**MEMORANDUM                      Planning & Development - CC Memo No. 08-198**

**SUBJECT:**        DVR08-0029 THE GATES  
                          Introduction and Tentative Adoption of Ordinance No. 4107

**Request:**        Rezoning from Agricultural (AG-1) to Planned Area Development (PAD) along with Preliminary Development Plan (PDP) approval for a commercial retail development on approximately 18-acres

INTERSECTION CORNER + SCREEN WALL

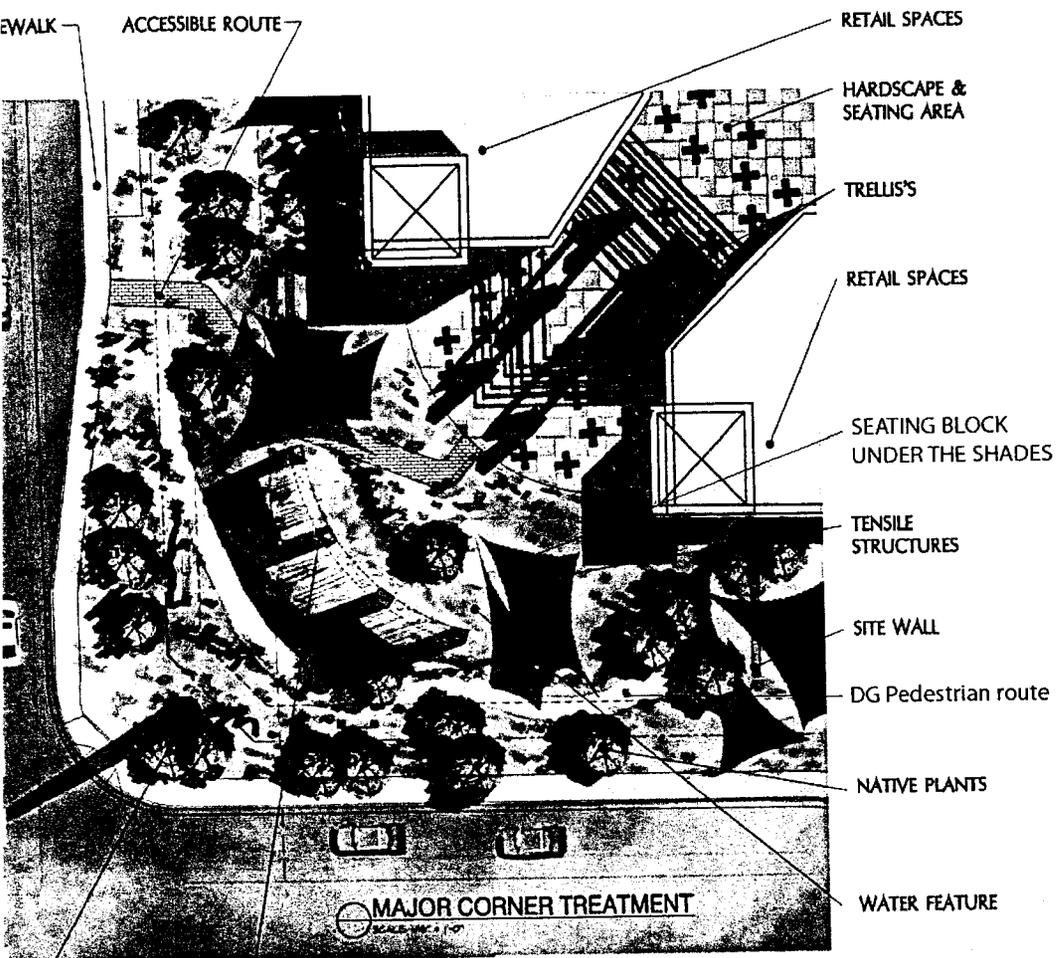
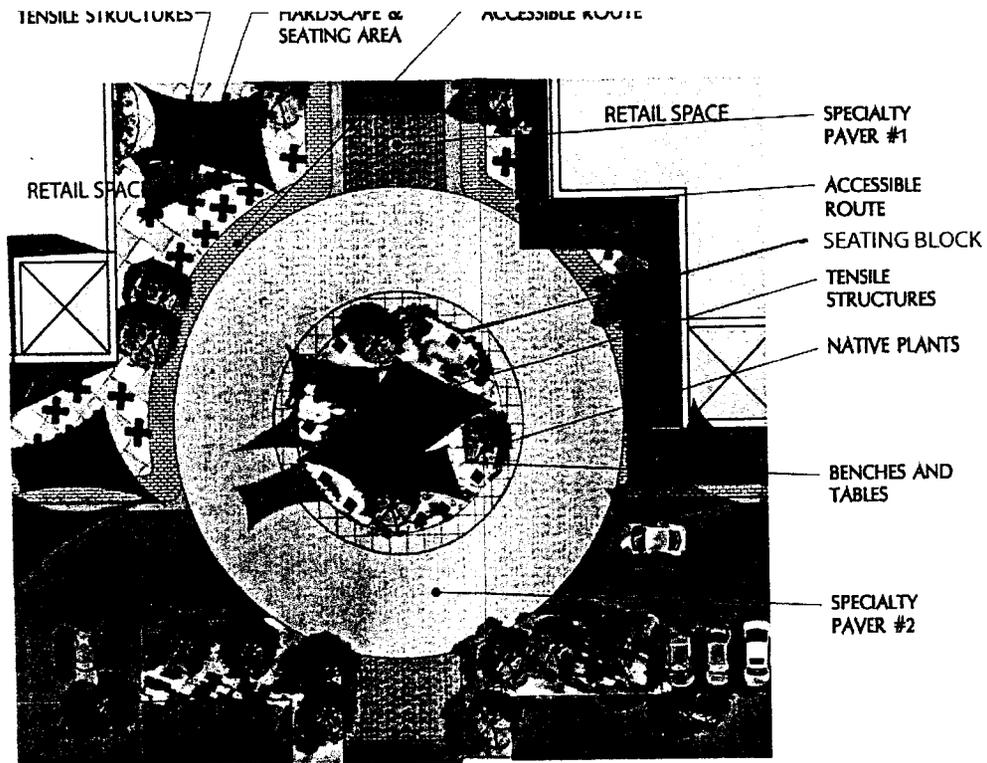
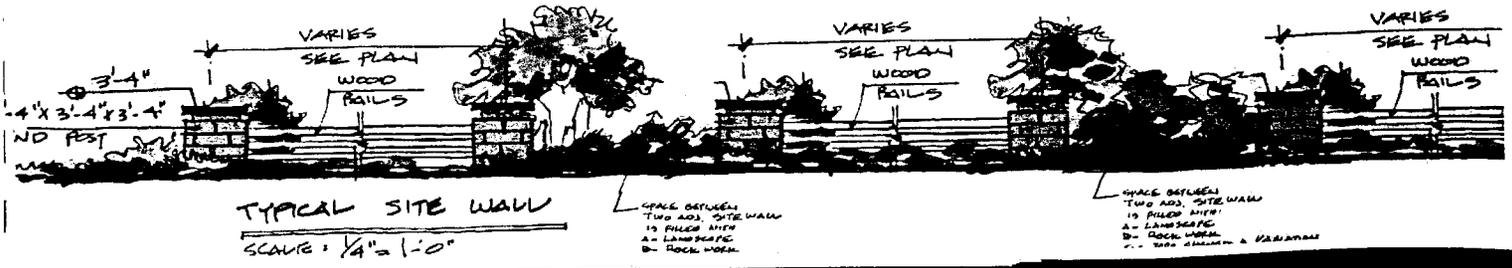
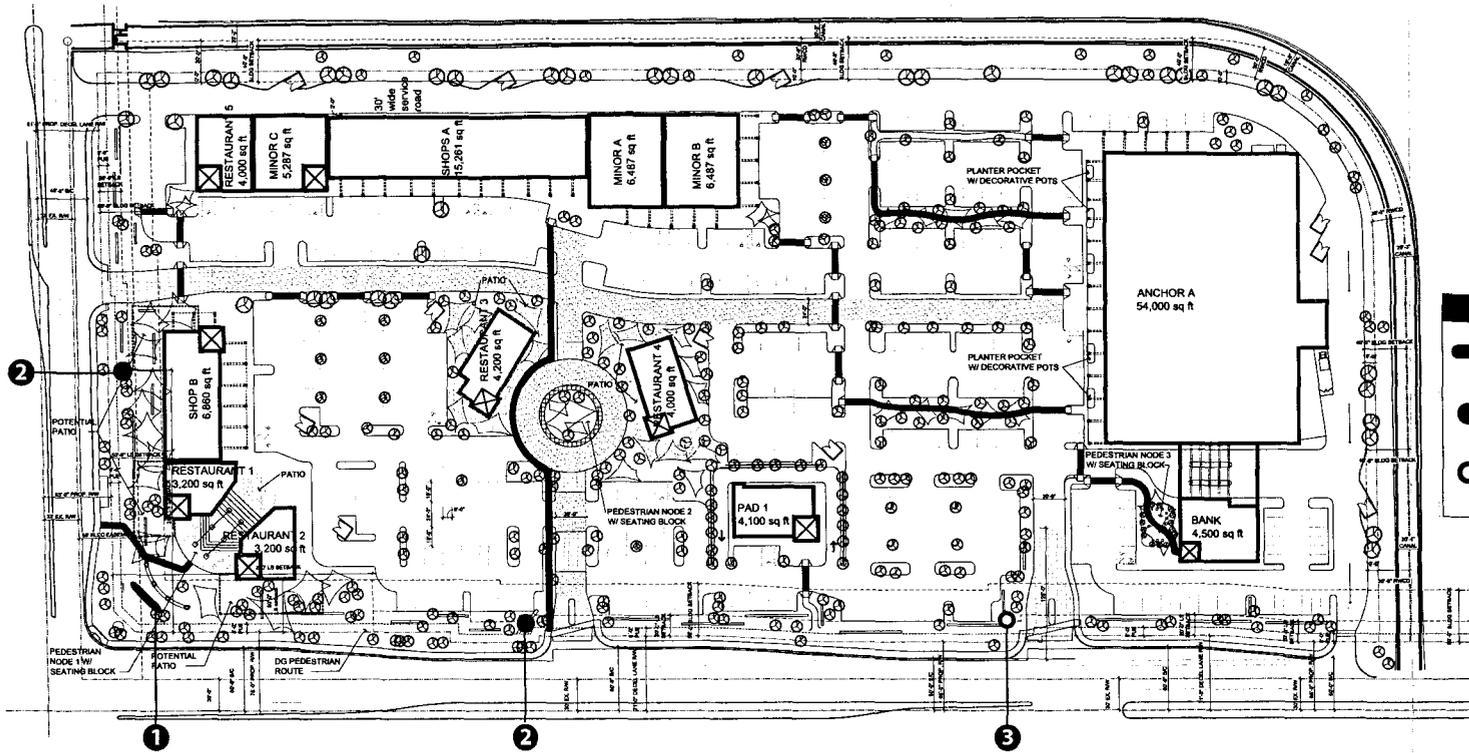
Located at the intersection corner is a strong pedestrian element. Care has been taken by the design team to integrate a number of elements to enhance the pedestrian experience. A water feature is provided at the intersection corner that serves as the required art feature. The water feature will shoot water into a small pond. The feature will utilize the cultured stone found elsewhere on the site. Also located at the intersection corner are two restaurant pads and an inline shops building located within a landscape setting. Along the street side of the buildings various tensile shade structures are provided, along with a number of pedestrian seating blocks and a decomposed granite walking path that runs the length of the development along Gilbert Road. A large outdoor pedestrian area is provided in between the two restaurant buildings to provide the potential for outdoor eating areas. On the site plan details are also provided for the potential of outdoor patios along the street frontages. The outdoor patios would encroach into the required landscape setback, however due to the nature of the encroachment Staff supports the request to provide the ability for the unique outdoor pedestrian amenities.

settings, and the water feature located at the intersection corner. With the unique amenities there is some deviation from code requirements. Both the tensile shade structures and outdoor patio areas located along the arterial intersection encroach into the required building and landscape setbacks. While the practice in the past has been to discourage encroachment in these setbacks Staff is in support of the deviation due to the nature of the request, finding that these are unique attractive alternatives that merit the encroachment consideration.

17. The building mounted signage for the buildings located at the intersection corner shall be limited to reverse pan-channel halo-illuminated lettering.

## [2] Primary Multi-Tenant Monument

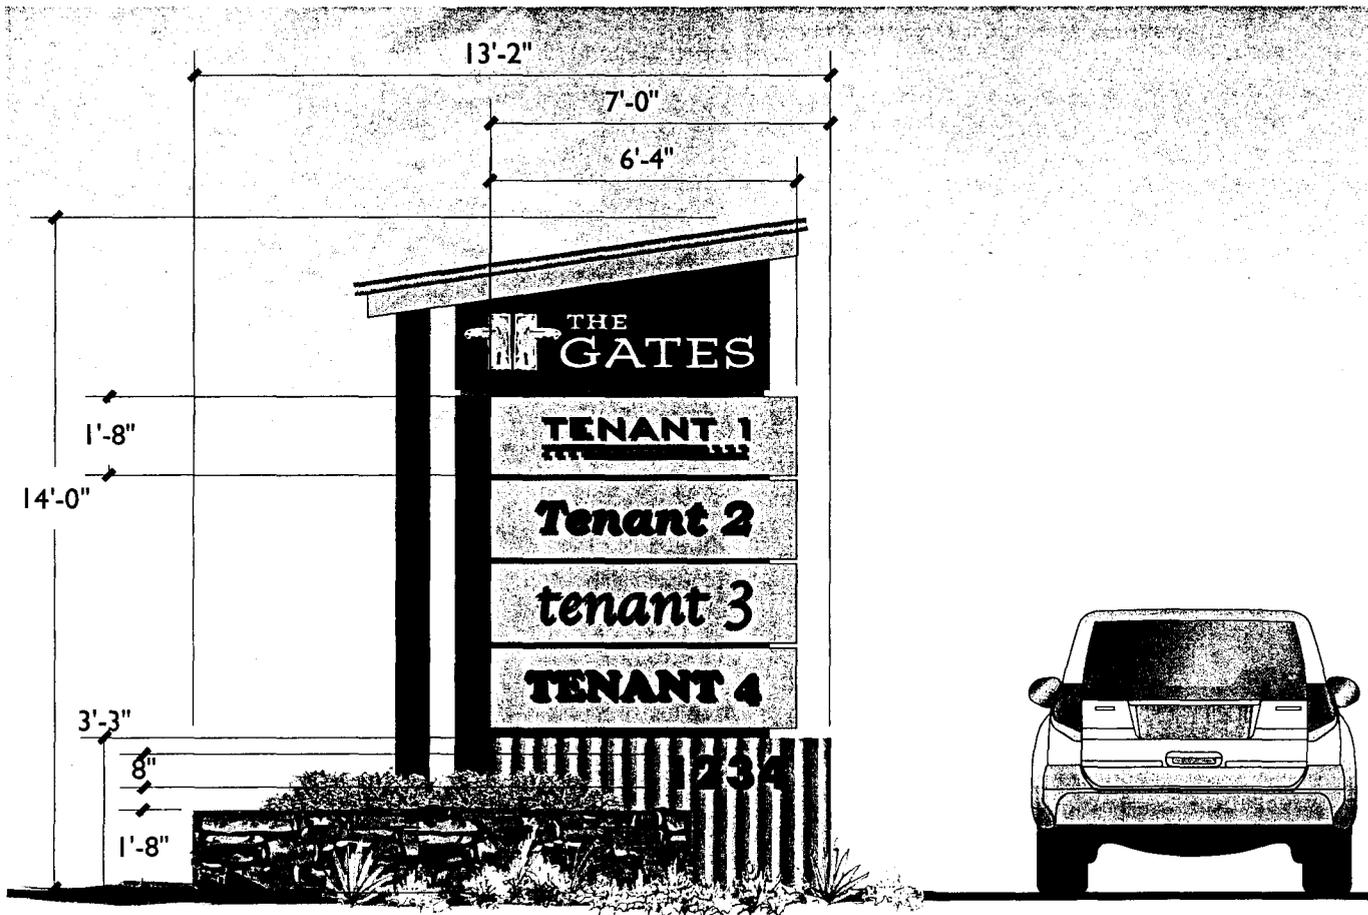
The request includes a Comprehensive Sign Package. The proposal requests a total of three monument signs; one along Ocotillo Road and two along Gilbert Road. Two monument sign designs are proposed. The primary monument sign will be approximately 14’ in height and will provide four tenant panels. The secondary monument sign is approximately 7’ in height with an additional three-foot architectural embellishment, and will provide two tenant panels. The monument signs will utilize a number of the materials found upon the buildings including; rough sawn timber, corrugated metal, and cultured stone. Both monument sign types will include planter boxes at the bases. The monument sign tenant panels will be reverse pan-channel halo illuminated. The Comprehensive Sign Package requests deviation from two Sign Code requirements; 1) the number of tenant panels allowed per monument sign, 2) the location of a sign at the intersection corner exceeding six-feet in height. The primary monument sign exceeds the number of tenant panels allowed by Code by two panels, however Staff is in support of the request for the additional tenant panels due to the monument signs level of design. Staff is also in support of the sign located at the intersection corner finding the uniqueness of the design meritorious.

8. The monument sign's sign panels shall have an integrated or decorative cover panel until a tenant name is added to the sign.
9. Landscaping shall be in compliance with current Commercial Design Standards.
